**R99CN**

**RECALL R99CN  
SCHOOL BUS PASSENGER SEAT WALL ATTACHMENT  
INSPECTION PROCEDURES**

**RECALL R99CN  
SCHOOL BUS PASSENGER SEAT WALL ATTACHMENT  
MODIFICATION INSTRUCTIONS**

**SUBJECT: RECALL R99CN REVISION - SCHOOL BUS PASSENGER SEAT WALL  
ATTACHMENT**

**Figure 1**

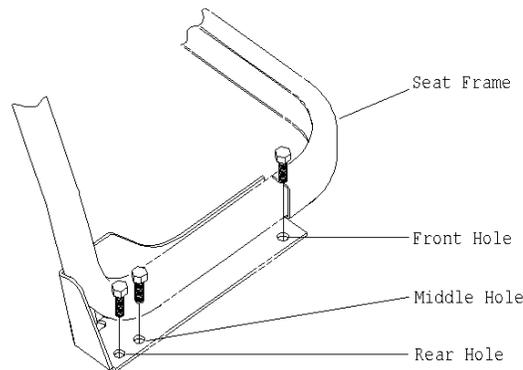
For all seats **without** seat belts, two (2) bolts are required. See Figure 1. One bolt will be located in the front hole. The second bolt will be located either in the middle hole or in the rear hole. Indicate the location of the bolts in each seat by placing a circle around front, middle or rear on the appropriate line on the inspection sheet.

Figure 2

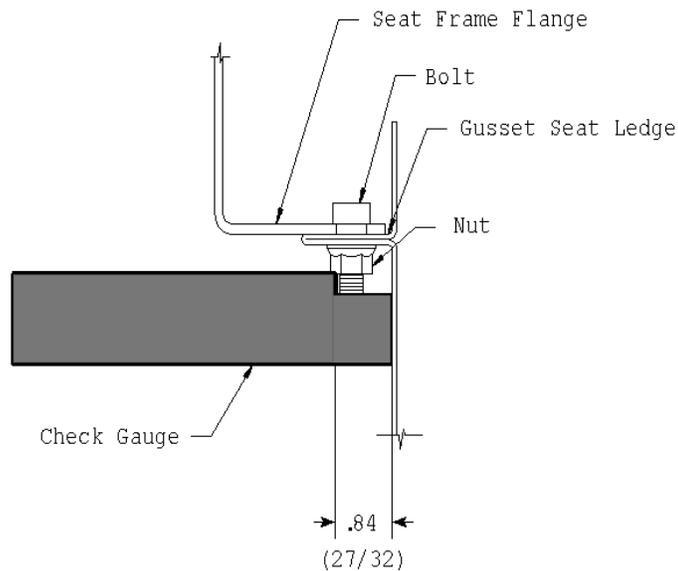
Place check gauge at centerline of each bolt that attaches seat frame to wall ledge. See Figure 2. If check gauge contacts bolt and **does not** contact bus sidewall, check "F" (Failed) on inspection sheet as indicated for each bolt position. If the check gauge contacts sidewall while lined up with centerline of bolt, check "P" (Passed) on inspection sheet as indicated for each bolt position. See Figure 2. *NOTE: When checking position of bolt from sidewall be sure check gauge is below nut as shown in Figure 2.*

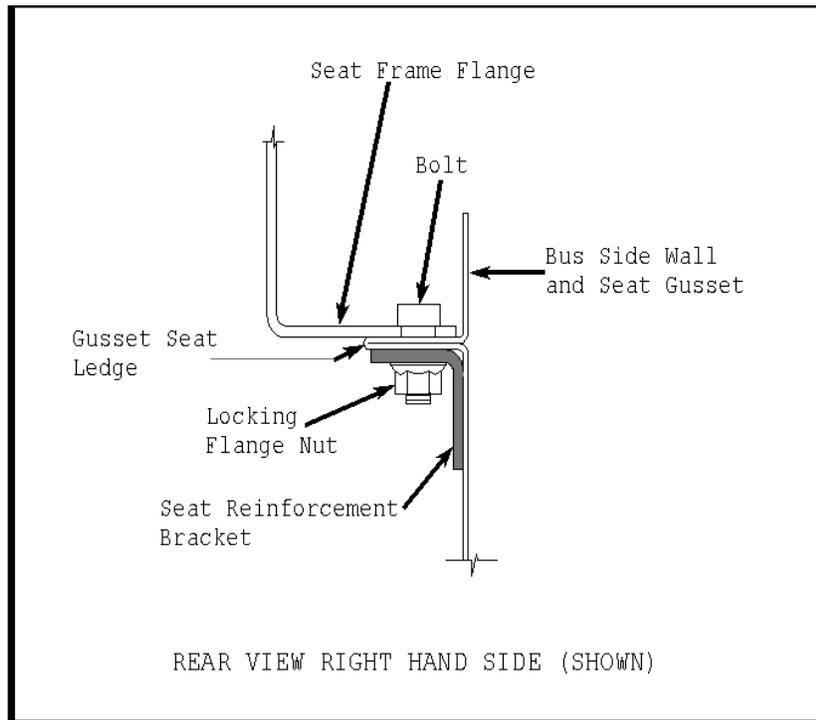
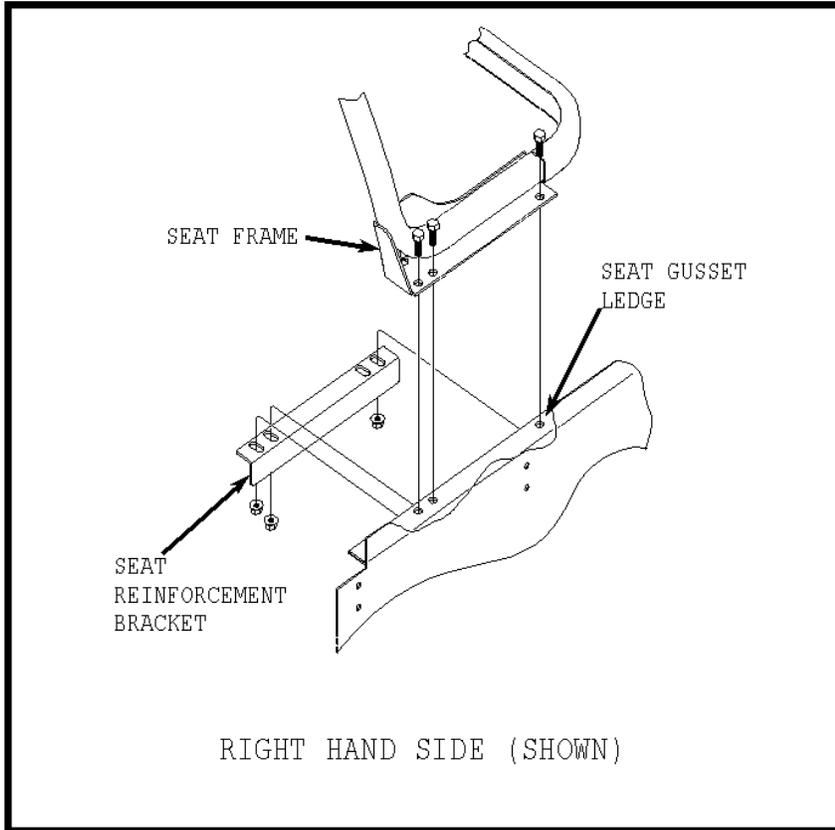
- a) If bus sidewall to bolt dimension passes when checked with check gauge, no modifications are necessary.
- b) If bus sidewall to bolt dimension fails when checked with check gauge, (see Figure 2 in Inspection Procedures) back drill 11/32" (0.343) diameter hole using rear hole in seat frame mounting bracket as a guide. Remove nuts from bolts located in front and middle holes. Place additional bolt (1032283) in hole drilled at rear of bracket. Install bracket (0007142) with three bolts (1032283) and nuts (0829390). Torque all fasteners to 18-20 ft. lbs. See page 2 of instructions for illustration of bracket installation.

- a) Back drill 11/32" (0.343) diameter hole using rear hole in seat frame as a guide. Remove nuts from bolts located in front and middle holes. Place additional bolt (1032283) in hole drilled at rear of bracket. Install bracket (0007142) with three bolts (1032283) and nuts (0829390). Torque all fasteners to 18-20 ft. lbs. See page 2 of instructions for illustration of bracket installation.

- a) If location of bolt passes when checked with check gauge, no modifications are required.
- b) If location of bolt fails when checked with check gauge, back drill an 11/32" (0.343) diameter hole using middle hole in seat frame as a guide. Remove nuts from bolts located in front and rear holes. Place additional bolt (1032283) in middle hole. Install bracket (0007142) with three bolts (1032283) and nuts (0829390). Torque all fasteners to 18-20 ft. lbs. See page 2 of instructions for illustration of bracket installation.

The reinforcing bracket (0007142) should be installed as shown in the illustrations below.
